Project	IEEE 802.16 Broadband Wireless Access Working Group < <a href="http://ieee802.org/16">http://ieee802.org/16</a> >	
Title	Unsolicited RNG-RSP in Non-transparent RS System under Distributed Scheduling	
Date Submitted	2006-03-13	
Source(s)	<p>Kanchei (Ken) Loa, Yi-Hsueh Tsai, Chih-Chiang Hsieh, Yung-Ting Lee, Hua-Chiang Yin, Shiann-Tsong Sheu, Frank C.D. Tsai, Youn-Tai Lee, Heng- lang Hsu Institute for Information Industry 8F., No. 218, Sec. 2, Dunhua S. Rd., Taipei City, Taiwan.</p>	<p>Voice: +886-2-2739-9616 <a href="mailto:loa@iii.org.tw">loa@iii.org.tw</a></p>
	<p>Hang Zhang, Peiyong Zhu, Mo-Han Fong, Wen Tong, David Steer, Gamini Senarath, Derek Yu, Mark Naden, G.Q. Wang Nortel 3500 Carling Avenue Ottawa, Ontario K2H 8E9</p>	<p>Voice: +1 613 7631315 <a href="mailto:WenTong@nortel.com">WenTong@nortel.com</a> <a href="mailto:pyzhu@nortel.com">pyzhu@nortel.com</a></p>
	<p>Yuefeng Zhou, Masato Okuda</p> <p>Fujitsu</p>	<p><a href="mailto:yuefeng.zhou@uk.fujitsu.com">yuefeng.zhou@uk.fujitsu.com</a></p> <p><a href="mailto:okuda@jp.fujitsu.com">okuda@jp.fujitsu.com</a></p>

# Unsolicited RNG-RSP in Non-transparent RS System under Distributed Scheduling

This contribution describe

Table yyy: Unsolicited RNG-RSP triggered by BR ranging code in non-transparent RS system under distributed scheduling

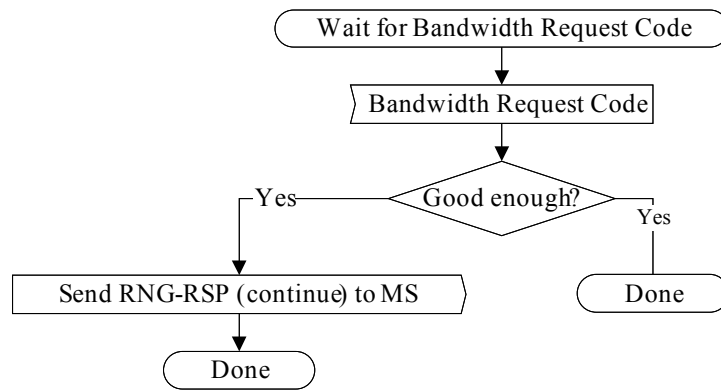
The RS should send an unsolicited RNG-RSP as a response to a CDMA-based bandwidth-request from MS, which results in continue status.

When RS receives the BR CDMA ranging code resulting in continue status, RS shall locally send RNG-RSP to MS on the access link.

The message sequence charts (Table 364, Table yyy) and flow charts (Figure zzz) define the unsolicited RNG-RSP process that shall be followed by compliant RSs and MR-BSs.
